CABINET MEMBER FOR ENVIRONMENT – 19 NOVEMBER 2020

MILTON: MILTON HILL - PROPOSED TRAFFIC CALMING MEASURES & 30MPH SPEED LIMIT

Report by Interim Director of Community Operations

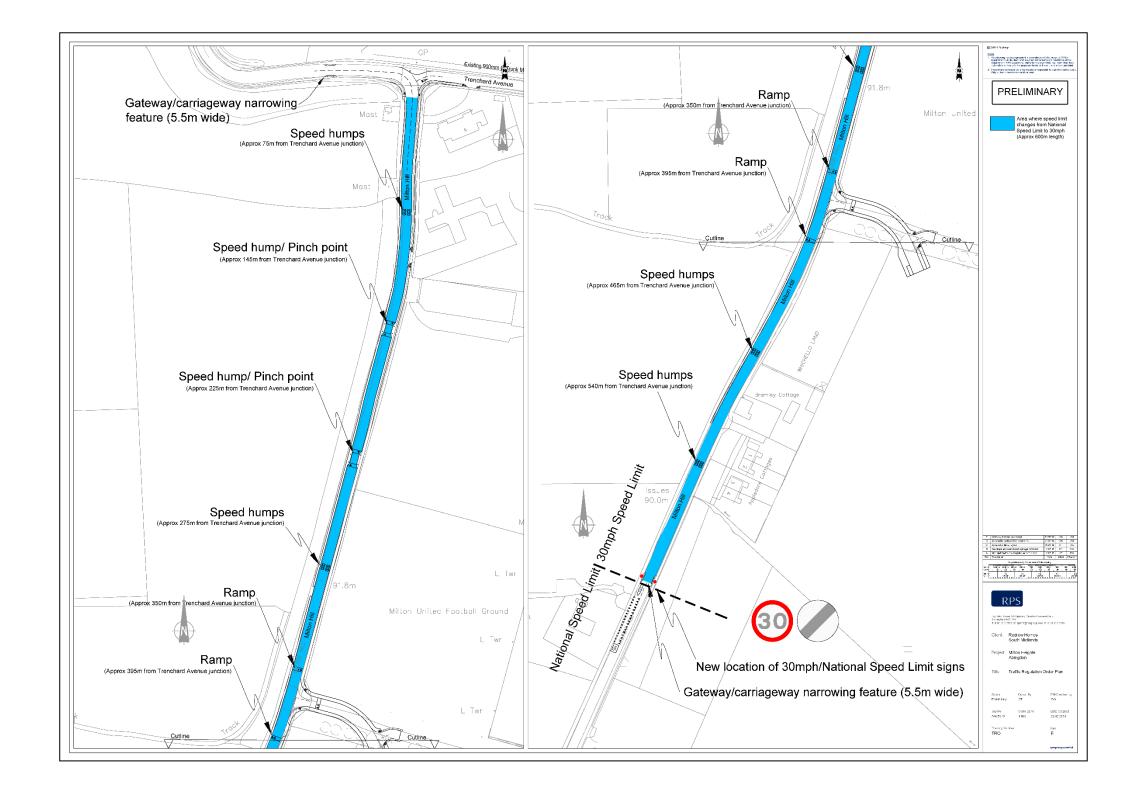
- 11. Cycling UK expressed support for the speed limit but concerns over the detailing of the proposed traffic calming measures in respect of the effectiveness of speed cushions and safety and ease of passage for cyclists including three-wheel pedal cycles. They requested consideration of cycle bypasses in accordance with current national advice on the provision for cyclists. This response also included a request for consideration of works to improve cycle amenity at the A4130/Trenchard Avenue junction, where no dropped kerbs are currently provided.

- 14. Two objections and four concerns were expressed by members of the public over the proposed traffic calming measures. The issues raised included the visual intrusion to the largely rural area, difficulties caused for access to the access to Appledore Cottages, flooding caused by obstructing the flow of water, damage to vehicles and the obstruction of vision splays from signs provided for the traffic calming measures. Noting these concerns, speed

- 15.A concern was also raised by a member of the public in respect of cycle safety and requesting consideration of cycle bypasses at the two proposed narrowing points and also that the position of one of these could be amended so as to also provide an uncontrolled crossing point for pedestrians adjacent to the access to a public right of way. Officers will investigate the feasibility of these changes but it's unlikely that they can be accommodated due to site constraints.

We also need to highlight that the proposed position of the road narrowing with entrance feature and signs to indicate the start of the 30mph limit would impede the vision splay when using the existing access of the property south Appledore Cottages. The "line of required vision splay 136m southbound, 140m northbound" required by the Highways department. Our suggestion would be to make all of Potash Lane 30mph with this clearly indicated at each end of the lane therefore avoiding traffic calming obstructions spread down the lane. Traffic Calming - Object Speed Limit - Support I fully support the proposed reduction in the speed limit but I object to the traffic calming measures as they are currently proposed. I live at number three Appledore Cottages with my severely disabled husband. We have lived here for thirty years. He has recently come home after ten months in hospital and is now confined to a wheelchair. We are already virtual prisoners in our home as the pavements are in such a disgraceful state that I have no option but to push my husband along a very busy road. The road slopes due to the enormous amount of work done on it by various utility companies over the years so the prospect of pushing my husband along a road that is also full of speed bumps is horrifying. Also, ours is probably the worst house to put a speed bump in front of as there are two carers cars (6) Local Resident. (Milton outside my house four times a day, plus a car parked there overnight for the night carer. In addition to all of this, we Hill) share our drive with our neighbours and have to reverse out onto the main road. To have to negotiate a speed bump whilst doing this would add to the problem of looking out for traffic coming both ways at speed. I have no objections to the idea of traffic calming measures but feel that outside 3 Appledore Cottages is the worst possible place for it. I am hoping to get a vehicle which will be wheelchair accessible for my husband and would probably be pursuing the idea of requesting a disabled access sign on the road so feel very strongly that this is not the best place for a speed bump. I have already contacted one of the Milton Parish councillors regarding the difficulties that I am facing so please do not add to my many problems by placing a speed bump directly outside my house. I do hope that you understand the concerns that I have and that I have my husband's best interests at heart.

(7) Local Group/Organisation, (Cycling UK Oxfordshire)	Traffic Calming - Concerns Speed Limit - Support We support speed limits. We support traffic calming and the location of the speed cushions looks appropriate but not the design which should conform to LTN 1/20. Speed cushions of the proposed design have 3 problems: they do not effectively slow traffic (particularly larger vehicles including increasingly common SUVs which are more dangerous in a collision with vulnerable road users), they push people cycling towards the gutter - an unsafe road position for several reasons, and they can destabilise a three-wheeled cycle. As a result, LTN 1/20 recommends humps with a 1.5m cycle bypass: 7.6.7 A separate cycle bypass allows the hump to be avoided altogether (with 1.5m spacing between any kerbs). Where cyclists have no choice but to travel over humps, care should be taken to ensure that the transition from road to hump has no upstand. 7.6.8 Speed cushions are a form of road hump and are therefore subject to The Highways (Road Hump) Regulations 1999. The dimensions allow wide tracked vehicles such as buses, ambulances and HGVs to straddle them. Cushions are not a preferred form of traffic calming on cycle routes because they constrain the ability of cyclists to choose their preferred position in the carriageway and are particularly hazardous to riders of three wheeled cycles. There is a significant cycle route gap that could be filled while work is being done in this area. The shared path along the A4130 from Milton Interchange to Steventon turn traffic lights is interrupted by Trenchard Avenue which has no dropped kerbs. Ideally this crossing should be upgraded to a raised table with cycle priority e.g. with a parallel crossing. At minimum it should have dropped kerbs on both sides and cycle route warning signs.

(8) Resident, (Sutton Courtenay)	Traffic Calming - Concerns Speed Limit - Support Please ensure safe passage at the narrowing features for cycles. Cycle bypasses should be provided to avoid conflict with motorists. Cannot tell from the plan but could one of the narrowing be placed at the access point to the public right of way to aid crossing?

- 12. Noting the above concerns, the type of calming measures proposed have been very widely used in Oxfordshire including on roads with high cycle flows and have been found to be effective and not present a difficulty or hazard to cyclists. The scope to adjust the lateral positioning of the cushions will be investigated to provide as close to the recommended 1.5m spacing as possible.

cushions have not been found to present an obstruction to vehicles entering or leaving adjacent accesses, or to impair the drainage of the carriageway, or damage to vehicles being driven reasonably. The diameter of the sign poles is not considered to present a material obstruction to the vision splays. Officers will however contact the respondent who had raised concerns about access for a wheelchair accessible vehicle to ensure that the siting of the proposed cushion does not present a difficulty.
